STAFF REPORT

SUBJECT: H-2020-0060

Horse Meadows Subdivision

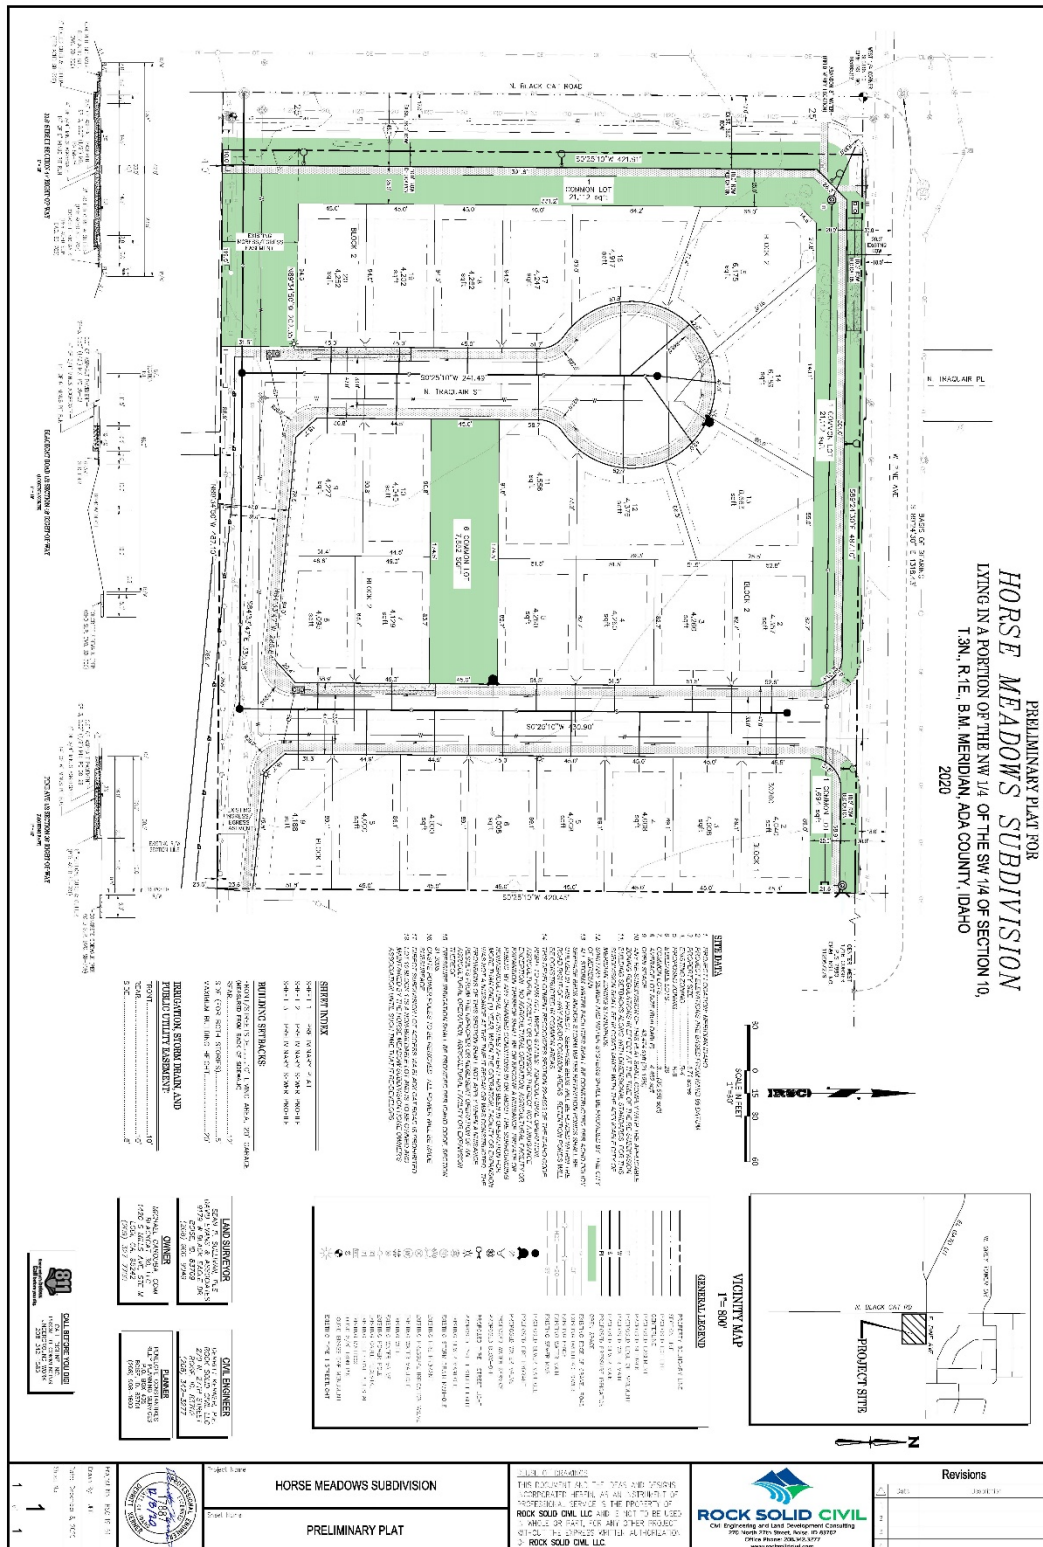
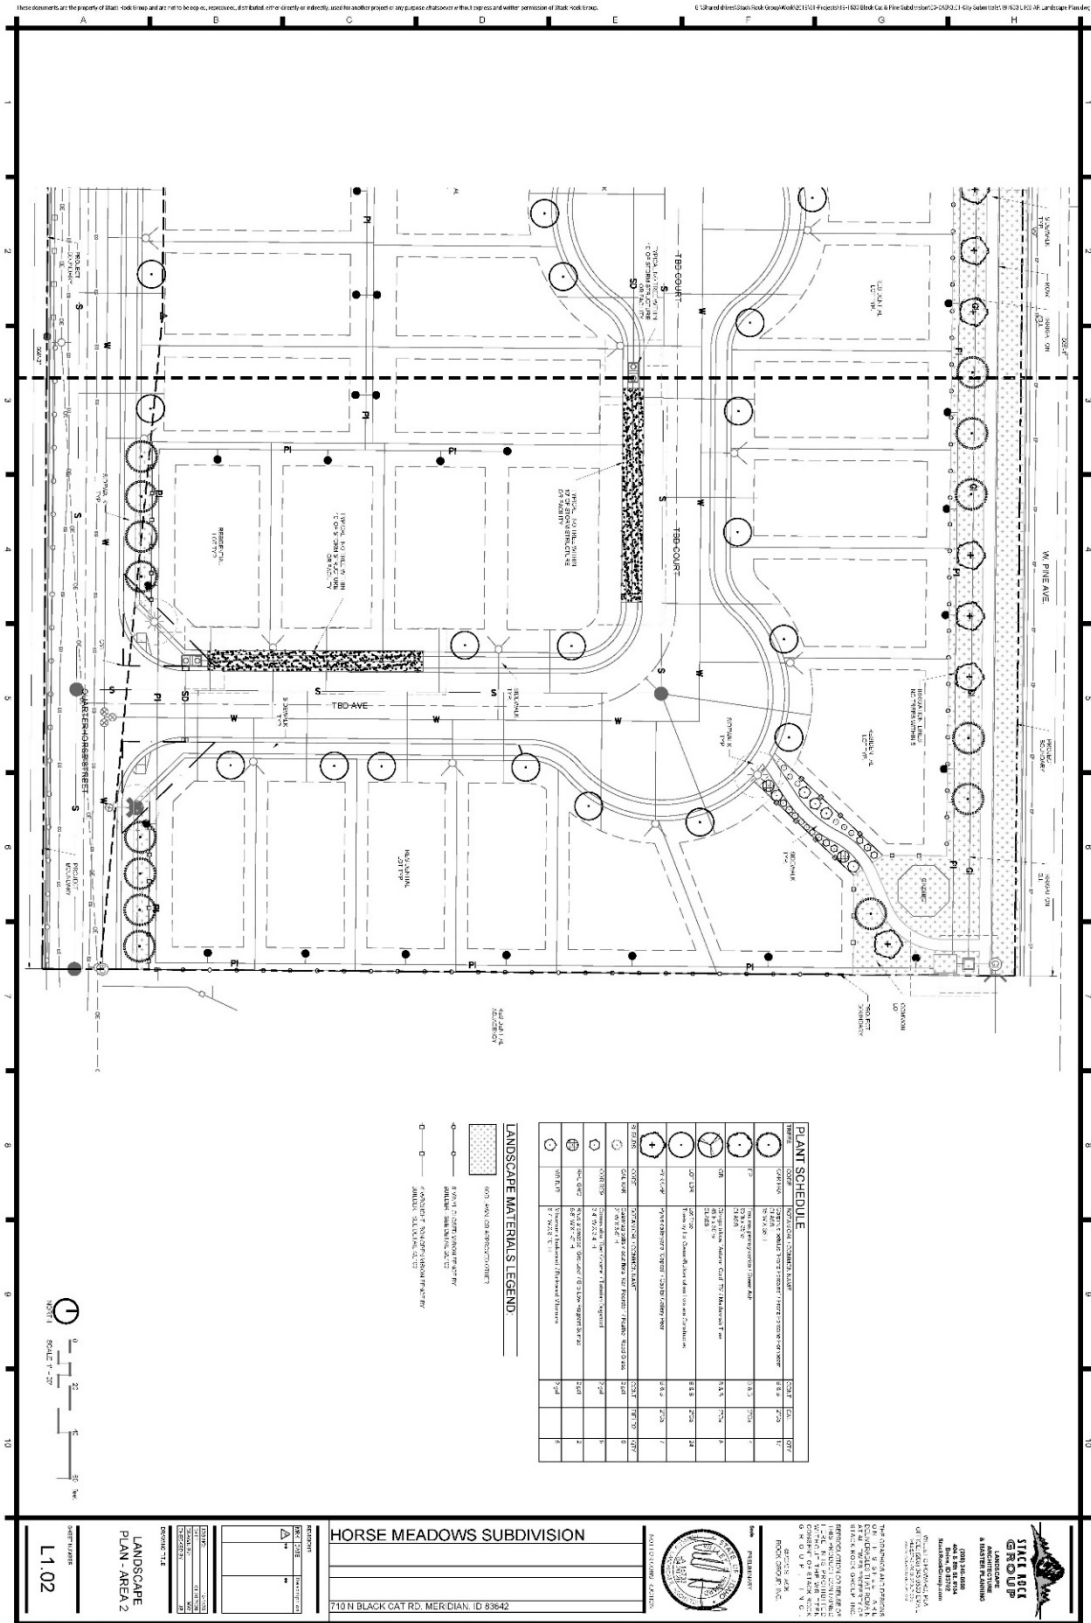
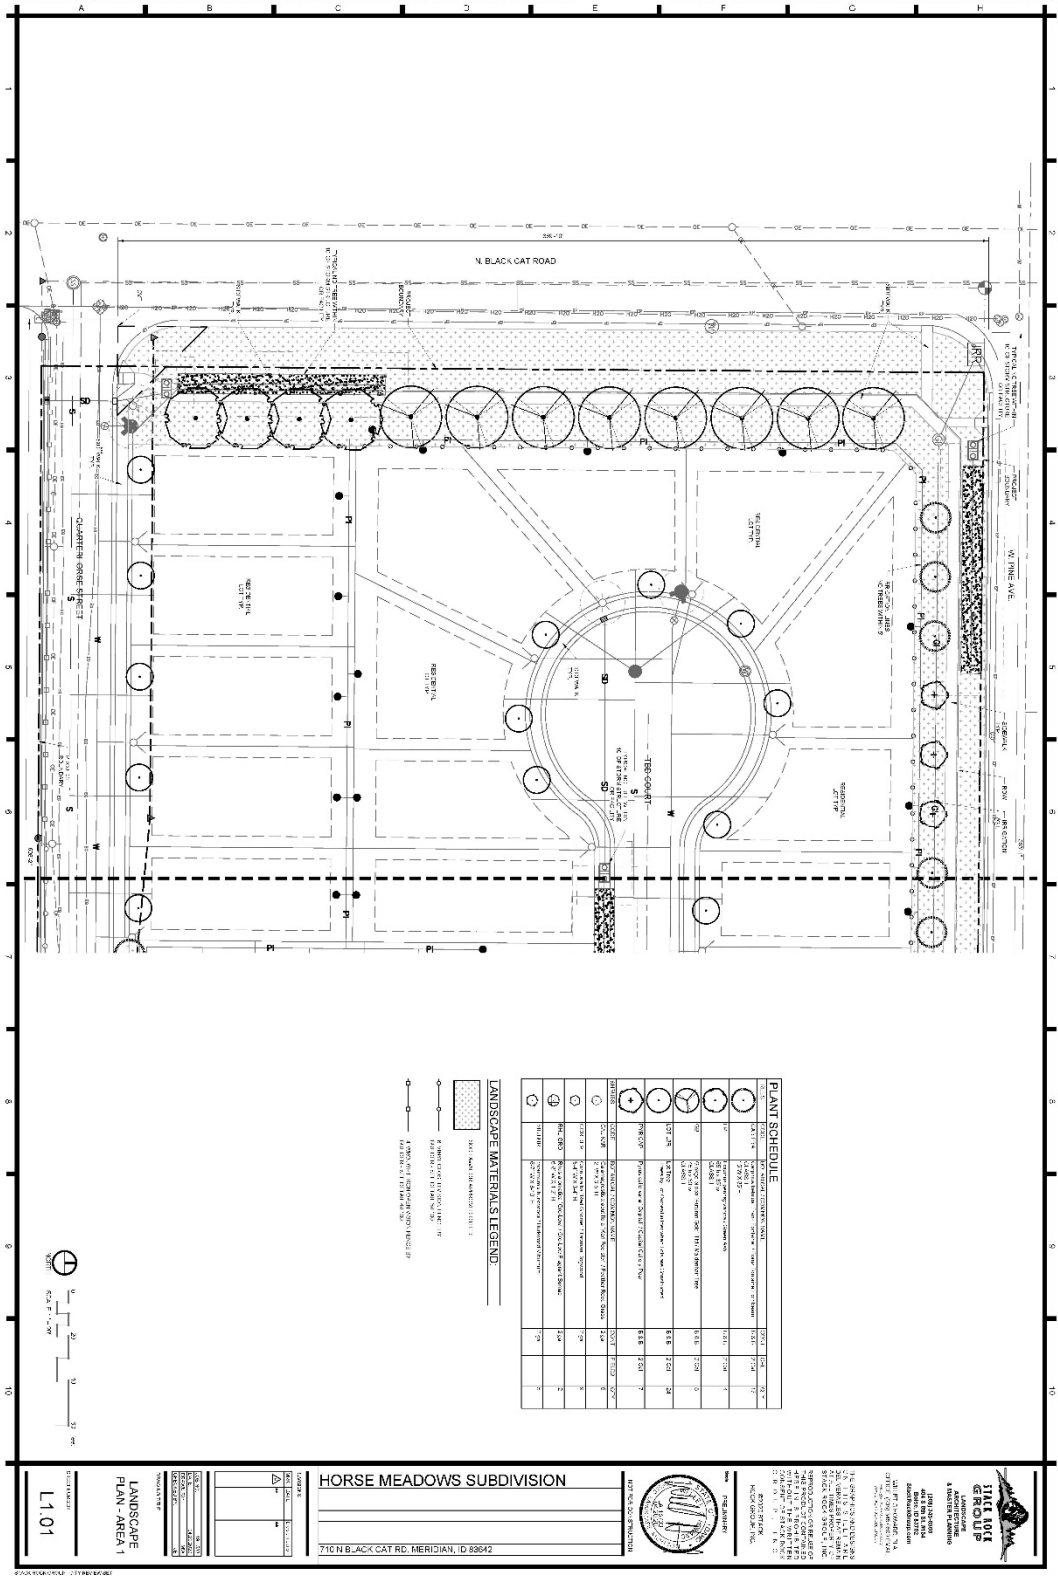
- b. The revised plat now shows the private lane easement as a common lot and dedicated right-of-way. If Council supports the revised plan, **Staff recommends DA provision 1.e be modified to read as follows: "A final plat application shall not be submitted until the Applicant receives approval and provides documentation from all easement holders (Parcels S1210325555, S1210325800, & S1210325710) to relinquish their rights to the existing access easement once the public road connection to Pine Avenue is constructed."**

- i. Construct a 5-foot wide micro-path along the south side of Lot 7, Block 1 that connects to the sidewalk along the west side of N. Traquair St. and to Black Cat Road.

2. ~~At least ten (10) days prior to the City Council hearing~~ Prior to Final Plat submittal, the preliminary plat included in Section VII.B, dated ~~09/01/2020 11/12/2020~~ 12/08/2020, shall be revised as follows:

- a. ~~Add a note prohibiting direct lot access via N. Black Cat Road.~~
 - b. Revise the plat to show the detached sidewalks along N. Black Cat Road and W. Pine Avenue with at least 4 feet of separation between it and the ultimate ACHD right-of-way.

- c. ~~Add a Revise plat note number 18 regarding stating that Lot 910, Block 1 to state: Lot 10, Block 12 is a non-buildable lot and is to be owned and maintained by the HOA until such time that it redevelops as either common open space or as and public right of way only.~~

- d. ~~Show Lot 6, Block 2 as a common open space lot instead of a building lot.~~
 3. ~~At least ten (10) days prior to the City Council hearing~~ Prior to Final Plat submittal, the landscape plan included in Section VII.C, dated 04/20/2020 shall be revised as follows:

C. Landscape Plan (date: 4/20/2020) (NOT APPROVED)

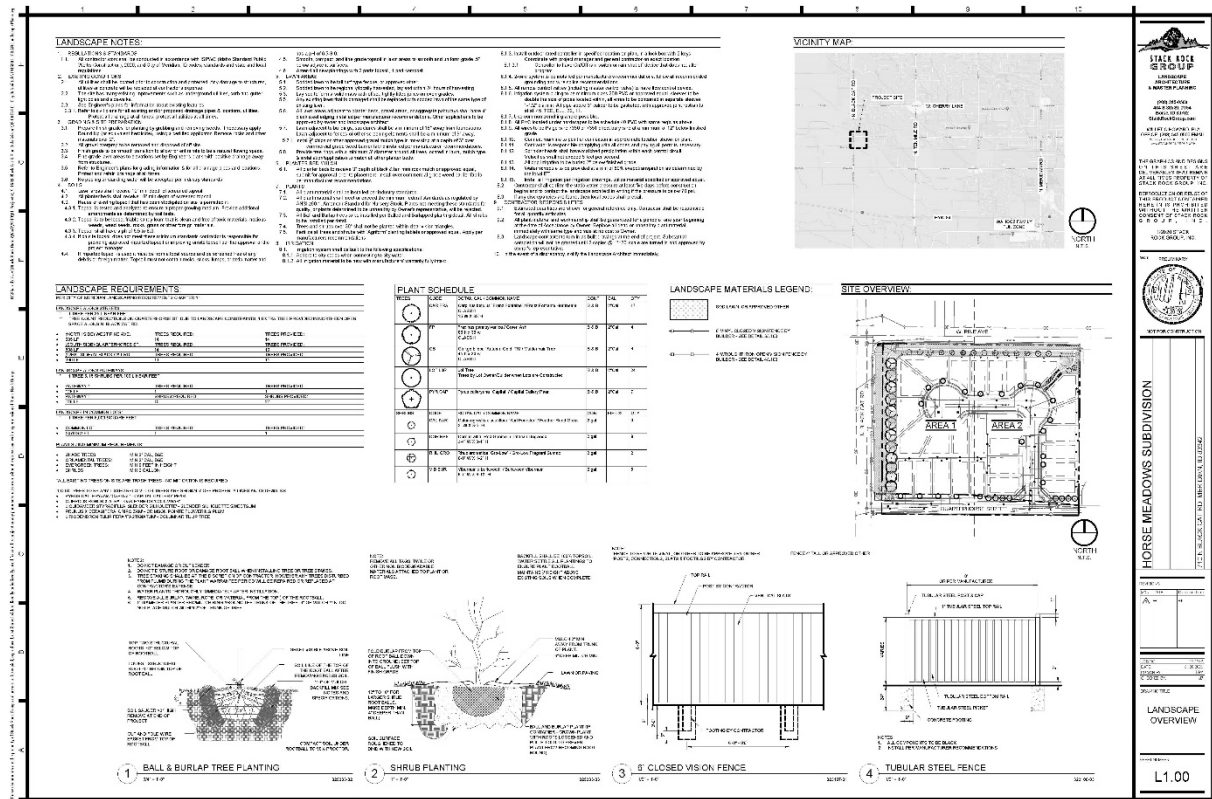
*The submitted plat depicts a 25-foot wide landscape buffer along Black Cat and a 20-foot wide buffer along Pine, both within common lots. The correct number of trees appeared to be shown on the original landscape plans as well (see Section VII.C). To ensure these buffers are installed and vegetated appropriately, the improvements required outside of the ultimate ROW should be constructed prior to receiving building permit approvals. Code also dictates that street landscape buffers are to be vegetated with shrubs, lawn, or other vegetative ground cover **in addition to** trees; the submitted landscape plans do not appear to show this vegetation. Staff is recommending a condition of approval to revise the landscape plans to correct this as well as revise the landscape plan to match the revised plat layout and be submitted to Staff no later than ten (10) days prior to the City Council hearing.*

- a. Revise the landscape plan to show the required shrubs and other vegetative ground cover within the street landscape buffers along N. Black Cat Road and W. Pine Avenue.

- b. Revise the landscape plan to show the layout of the revised preliminary plat; make any adjustments to the calculations table if needed.
- c. Revise the landscape plans to show the detached sidewalks along N. Black Cat Road and W. Pine Avenue with at least 4 feet of separation between it and the ultimate ACHD right-of-way.

- d. Show Lot 6, Block 2 as a common open space lot instead of a building lot with the correct vegetation as set forth in UDC 11-3G and 11-3B.
- e. Revise the landscape plans to show Lot 40 8, Block 1 with the required vegetative ground cover.

- f. Add a detail of the proposed ~~tot lot~~ amenity to the landscape plans to ensure quality of structures.
- g. Construct a 5-foot wide micro-path south of Lot 20, Block 2 that connects to the sidewalk along the west side of N. Traquair St. and to Black Cat Road.

D. Conceptual Building Elevations

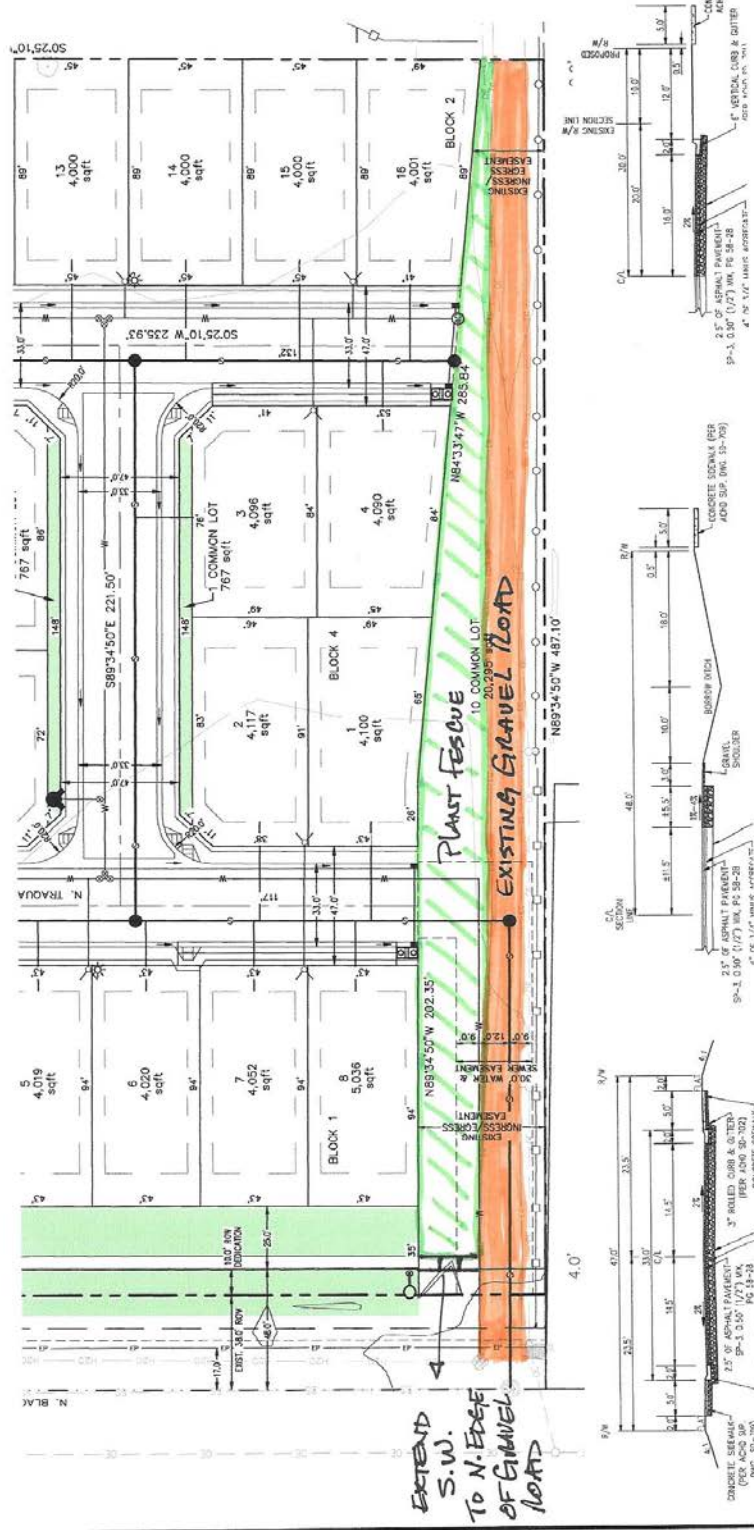
The submitted elevations show a combination of single and two-story single-family homes. The elevations also show different architectural elements, finish materials, and overall design options including some RV size garage spaces. However, with such small lot sizes proposed, Staff is concerned the submitted elevations may not depict homes that can actually fit within the building envelope of the R-8 zoning district. To help staff see this, Staff is recommending a condition of approval that the Applicant provide an exhibit showing how a proposed home will fit on these lots. However, the Applicant has not provided conceptual elevations of the alley loaded or side-loaded unit types. Prior to the City Council hearing, the Applicant should provide these conceptual elevations. Design review is not required for single-family detached structures but Staff finds the submitted elevations meet the requirements in the Architectural Standards Manual. Because a number of the homes abut streets that are heavily traveled, Staff is recommending a condition of approval that requires those homes abutting both Black Cat and Pine are constructed with modulation and variations in materials to mitigate any potential of a monotonous wall plane along these streets.

- 5. Outstanding issue(s) for City Council:
 - a. The Applicant has not submitted different elevations based on the Commission's recommendations because the submitted elevations are the designs that are intended to be constructed in the development.

10. The façade of structures that face N. Black Cat Rd. and W. Pine Ave. shall incorporate articulation through changes in materials, color, modulation, and architectural elements (horizontal and vertical) to break up monotonous wall planes and roof lines in accord with UDC 11-3A-19 and the Meridian Design Manual.
